CITY OF LEWISTON
PLANNING BOARD MEETING
Monday, March 26, 2018 – 5:30 P.M.
City Council Chambers – First Floor
Lewiston City Building
27 Pine Street, Lewiston, ME

TO: Planning Board
FROM: David Hediger, City Planner
DATE: March 23, 2018
RE: March 26, 2018 Agenda Item IV(a)

An application submitted by Sitelines P.A. on behalf of Federal Distributors, Inc. to construct a 23,612 sf addition to existing building located at 2019 Lisbon Street.

**Re: Response to Comments #1
Federal Distributors Building Expansion
2019 Lisbon Street, Lewiston, Maine
Map 46 - Lot 12**

FIELD WK: MC/CR	SCALE: 1"=40'	SHEET:
DRN BY: JIM	JOB #: 2714	C2
CHD BY: CYN	MAP/LOT: 46/12	
DATE: 01-17-18	FILE: 2714-SITE

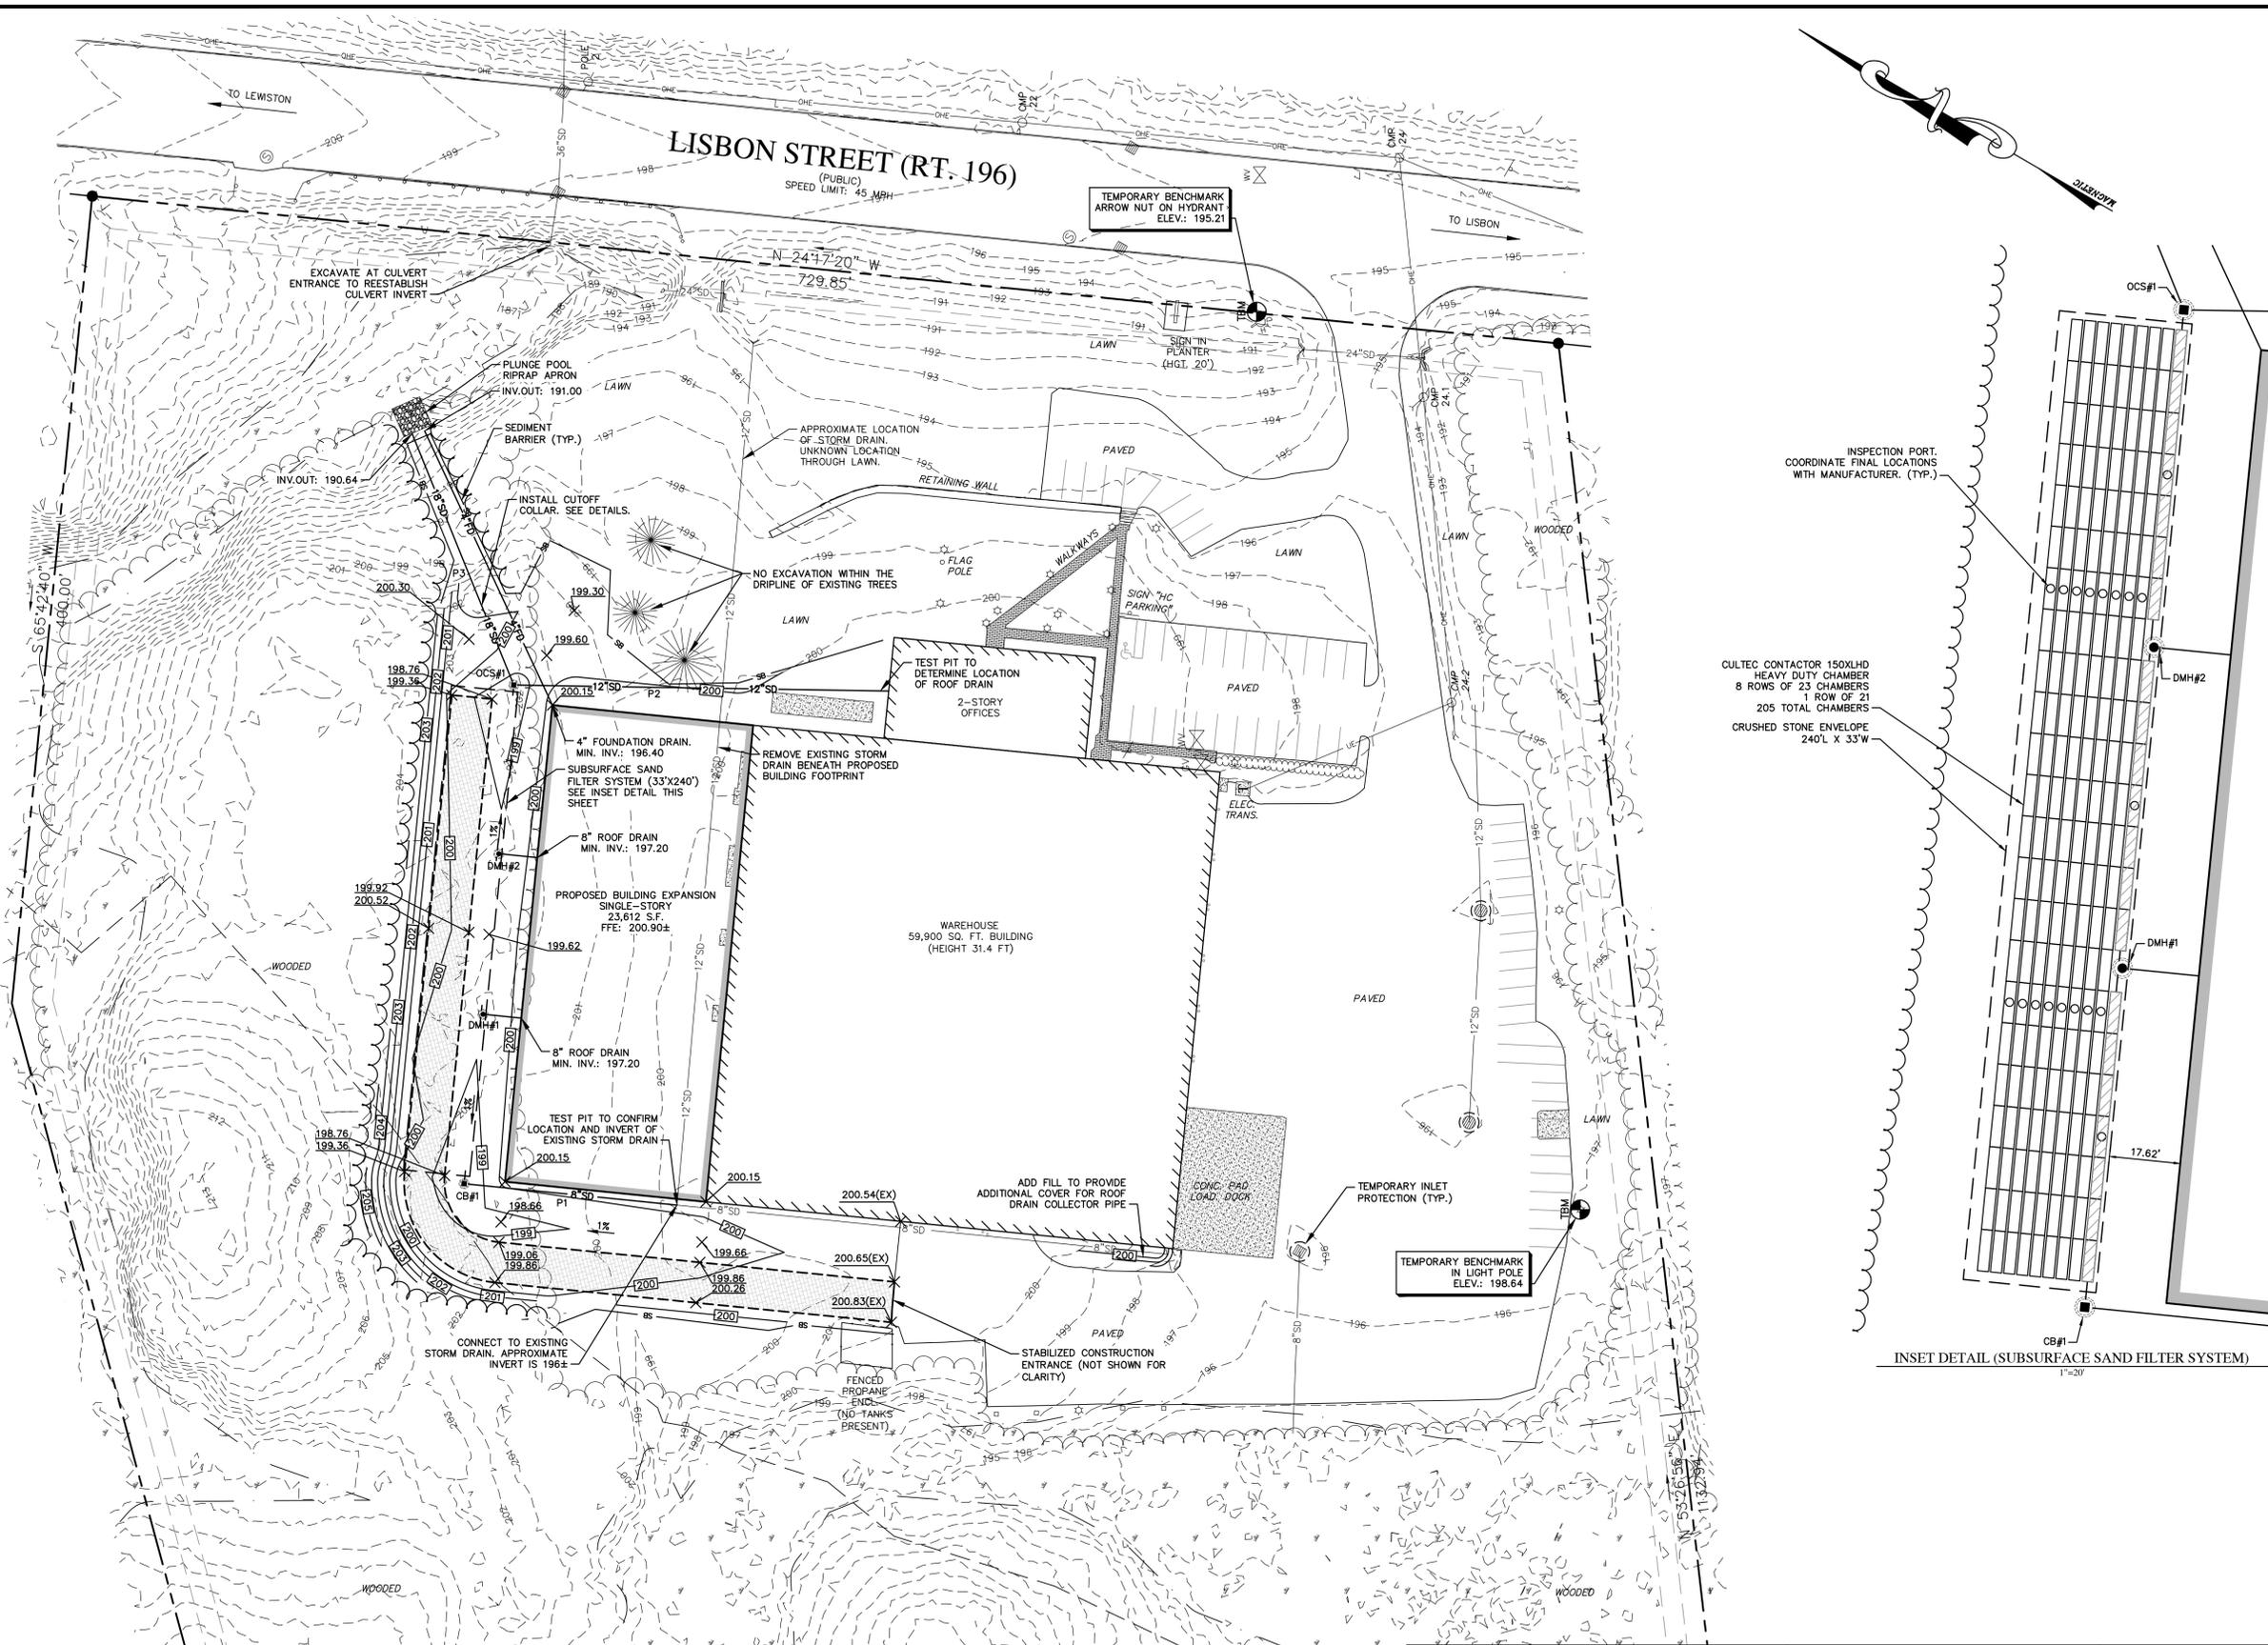
3. *Note must be added to the site plan referencing the plans expiration of approval: see Article XIII, Section 11(a)(1).*

The Site Plan has been revised to include the requested note.
